Project	IEEE 802.16 Broadband Wireless Access Working Group < http://ieee802.org/16 >	
Title	Enhancement of Scanning and Association using SCAN-REQ/RSP	
Date Submitted	2004- 07-0712	
Source(s)	Sungjin Lee, Yeongmoon Son, Jungje Son, Changhoi Koo Samsung Electronics	Voice: +82 31 279 5248 steve.lee@samsung.com
	Phillip Barber Broadband Mobile Technology	Voice: +1 (972) 365-6314 pbarber@BroadbandMobileTech.com
	Min-Sung Kim, Jeong-Hwi Kim, Seong-Choon Lee KT	Voice: +82-2-526-6109 mailto:cyberk@kt.co.kr
	Sang-Yun Han, Jinyong Chung, Jae-Hak(Steve) Lee SOLiD Tech., Inc.	Voice: +82-2-2142-3881 mailto:syhan@st.co.kr
Re:	This contribution is response to call for contribution about IEEE 802.16e-D3	
Abstract	This document proposes the scheme enhancing scanning and association operation with SCAN-REQ/RSP	
Purpose	Discuss and adapt proposed text and message format.	
Notice	This document has been prepared to assist IEEE 802.16. It is offered as a basis for discussion and is not binding on the contributing individual(s) or organization(s). The material in this document is subject to change in form and content after further study. The contributor(s) reserve(s) the right to add, amend or withdraw

Figure E.2—Example BS advertisement and scanning (with association) by MSS request

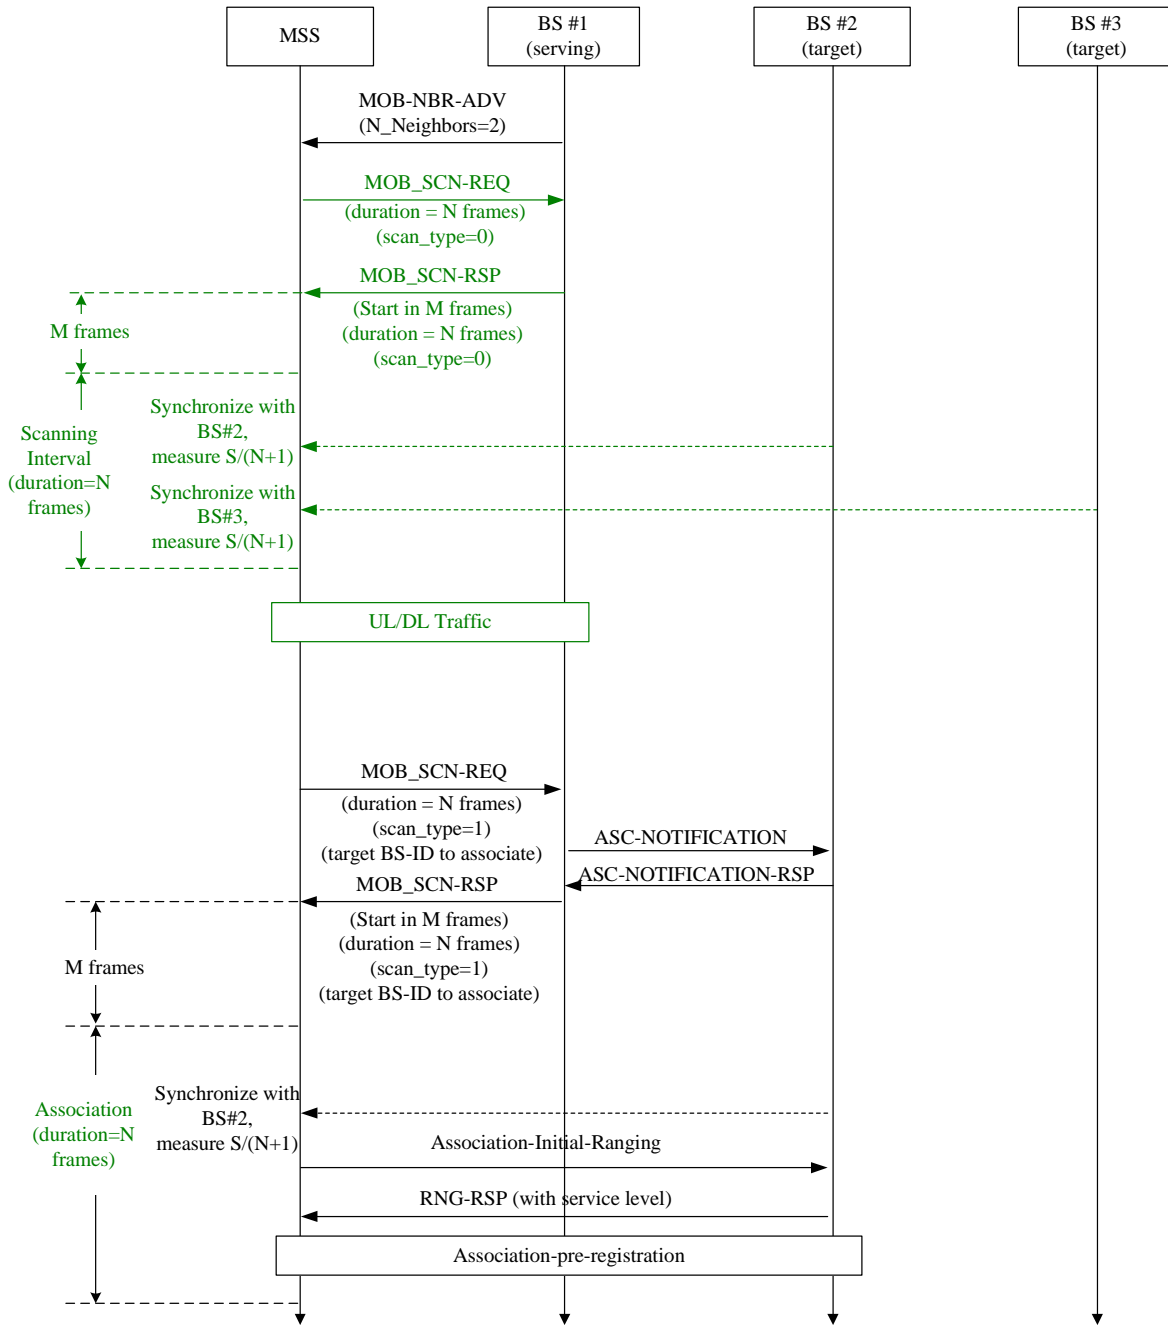
associated BS for the purpose of setting initial ranging values in future ranging events. In order to perform association during scanning interval, a MSS may transmit MOB-SCN-REQ message to the Serving BS with Scan_Type field value '1'. A Target BS ID for association is added if the MSS already have selected one target BS based on neighbor information have gathered former scanning operation.

Upon reception of this message, the BS may request target BS to allocate invited ranging opportunity to MSS for association and receive response message from target BS. If Association is accepted, the Serving BS shall respond to the MSS with a MOB-SCN-RSP MAC Management message with Scan_Type=1 and neighbor BS ID that is requested by MSS or selected by the Serving BS.

Following reception of a MOB-SCN-RSP MAC Management message, an MSS shall try initial ranging to target BS that is recommended by target BS-ID in MOB-SCN-RSP message. The target BS may allocate invited ranging opportunity for the MSS.
